Report: TAB Report CFA# 01527
Function: Test, Adjust, & Balance
Date: 10/27/2023

**10-16-23 CHICK-FIL-A #01527 - EXTON, PA
(LIONSVILLE, FSU) REINVEST**

H1Lmissinggreasecup.j..
10/19/2023

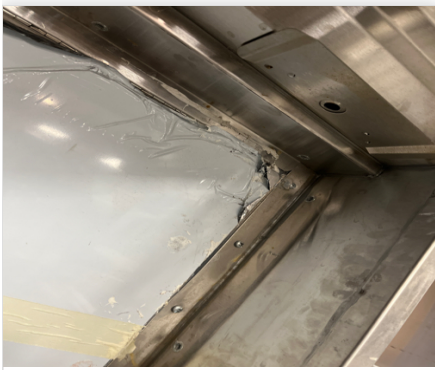
Issue Name : NON-CRITICAL: HD 1L grease cup
Description : Hd1L is missing it's grease cup. If not found on-site contact Halton to order replacement.
Created By : National TAB **Assigned To :** National TAB - Tyler Youells
Status : Open
Originated Date : 10/19/2023 - Tyler Youells - National TAB
